LINCOLN/LANCASTER COUNTY PLANNING STAFF REPORT

P.A.S.: Waiver of Design Standards #02018

PROPOSAL: Waive sidewalk and street lights on the east side of S.W. 27th Street and paving of S.W. 27th Street associated with Aspen Ridge 1st Addition final plat.

ASPEN RIDGE 1st ADDITION

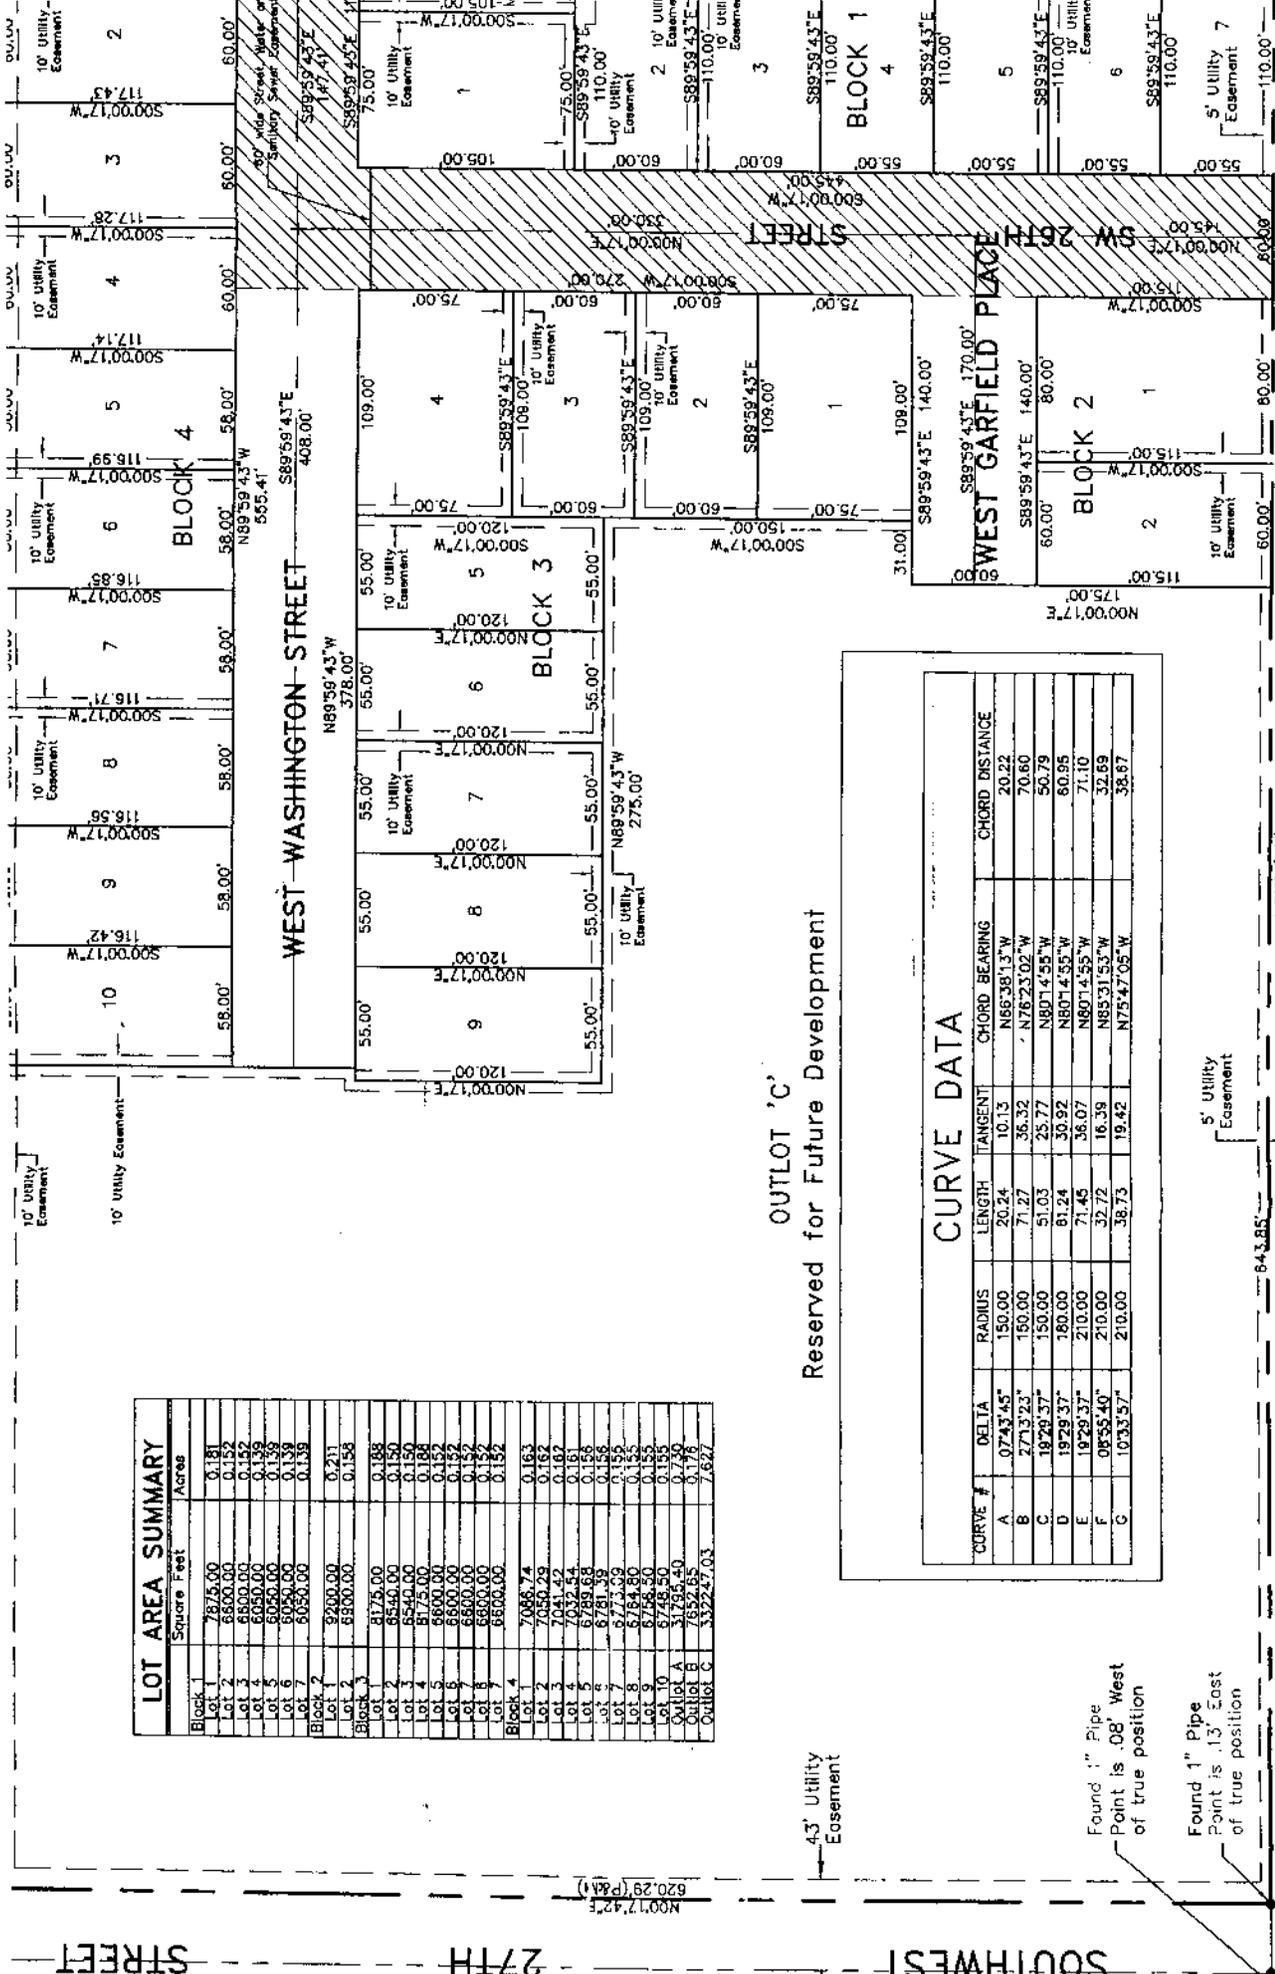
1. This request is to waive the sidewalk and street lights on the east side of S.W. 27th Street (Sec. 26.23.095 and 26.27.070) and street paving of S.W. 27th Street (Sec. 26.27.010).
2. The applicant's letter states that the city has requested sidewalks on both sides of S.W. 27th Street. The sidewalk is only required on the side of S.W. 27th Street abutting the final plat of Aspen Ridge 1st Addition.
3. The applicant's letter requests a waiver to landscaping. The preliminary plat of Aspen Ridge did not require landscaping or street trees on S.W. 27th Street.

4. Public Works supports the waiver of the paving and sidewalk on S.W. 27th Street until the time that W. Washington Street is platted to complete the connection with S.W. 27th Street.
5. There are no buildable lots being platted with the final plat of Aspen Ridge 1st Addition abutting S.W. 27th Street. Traffic on S.W. 27th Street most likely will not increase with the approval of Aspen Ridge 1st Addition final plat.

The developer has requested waivers to subdivision requirements for paving, street lights and sidewalks in Southwest 27th Street adjacent to Aspen Ridge 1st Addition. Since this plat is platting an outlot reserved for future development and is not platting any streets or lots that take access to Southwest 27th Street other than the outlot Engineering Services recommends, these requirements should be waived with this plat. This requirement should be imposed when buildable lots are platted with Southwest 27th Street frontage or a street is platted accessing Southwest 27th Street.

<u>RECOMMENDATION:</u>	Approval with the condition that when W. Washington Street is connected with S.W. 27 th Street all improvements will be required.
-------------------------------	--
